White's
Comments

Procedure No. W-SITP-4

REINFORCING STEEL - HANDLING, STORAGE, INSTALLING,
CADWELDING AND MODIFICATION INSPECTION

WATERFORD SES UNIT NO. 3
CONTRACT NO. W3-NY-4

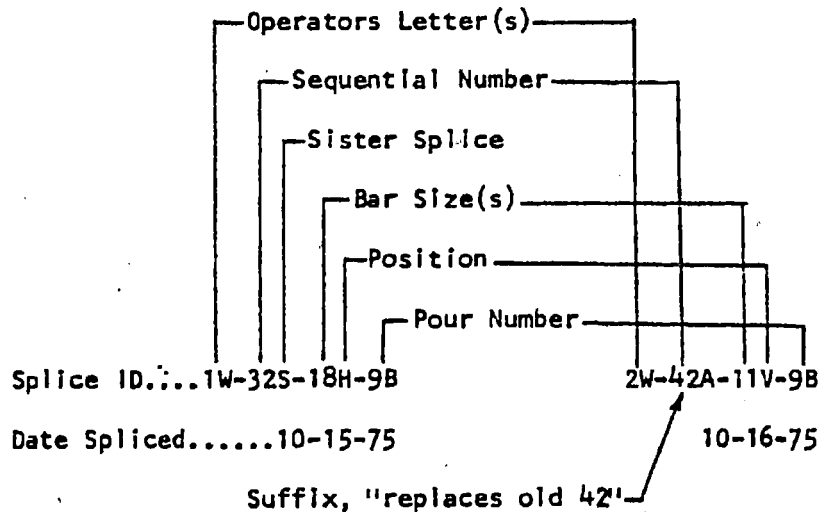
to 9.2.3

32
